APPLICATION FOR A CERTIFICATE OF APPROPRIATENESS – SUMMARY PROCEEDING

COA-0163-2019 704 N EAST STREET

Nature of Project: Construct screened porch; remove deck

STAFF REPORT

SITE INFORMATION FOR REFERENCE ONLY - REFER TO SURVEY PLOT PLAN FOR MORE DETAIL

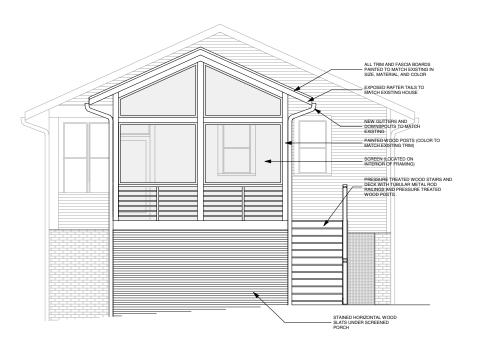
15* A tree survey identifying trees greater than 8" DBH on the property was provided. A plan

identifying locations for materials storage and refuse staging was provided. A tree

protection plan was not provided. The application states that no trees will be disturbed as a

result of the project.

1. That the materials staging plan be revised to show tree protection fencing parallel to the

north and east property lines.

2. That tree protection plans be implemented and remain in place for the duration of

construction.

BUILT TO OPEN AREA CLACULATIONS				
LOT AREA: 5285 sf				
EXISTING BUILT AREA: 1396sf	RATIO OF BUILT TO OPEN: 26%			
NEW BUILT AREA: 1708sf	RATIO OF BUILT TO OPEN: 32%

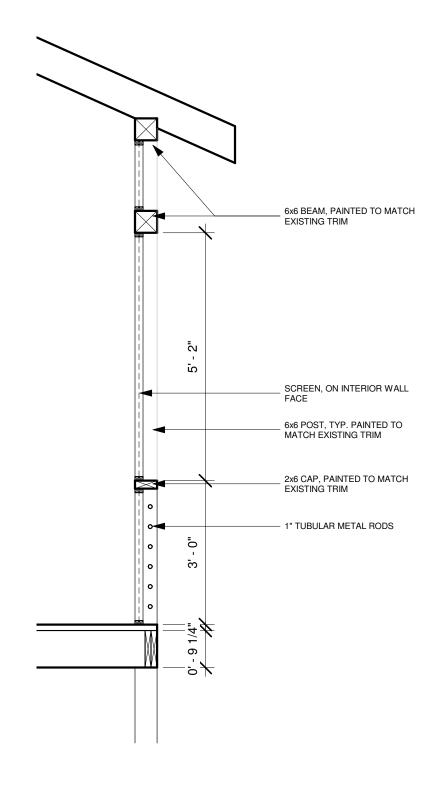
- 7* **Built mass to open space analysis**: According to the application, the lot totals 5,285 SF with an existing built mass of 1,396 SF. The existing built mass to open space is 26%. The proposed addition adds 312 SF for a total proposed built mass of 1,708 SF. The proposed built area is 32%, this results in an increase of 6%.

- 8* The Design Guidelines refer to not substantially increasing the **original** built mass to open space. Calculations were not provided for the property's original area mass. An addition was approved in 1996 (167-96-CA).
